Product Change Notification - KSRA-03HDBO264

CCB 3040 Final Notice: Implementation of new 7 inch plastic reel with new hub size for selected Micrel and Atmel products for 8mm and 12mm tape width.

KSRA-03HDBO264 - CCB 3040 Final Notice: Qualification of new 7 inch plastic reel with new hub size for selected Micrel and Atmel products for 8mm and 12mm tape width.

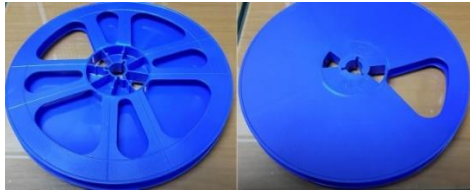
Pre Change:
Hub size is 2.0 inches

Post Change:
Hub size is 2.4 inches

Pre Change	Post Change
Hub Size	2.0 inches	2.4 inches
Tape Width Size	8 mm	8 mm
	12 mm	12 mm
8mm		
12 mm
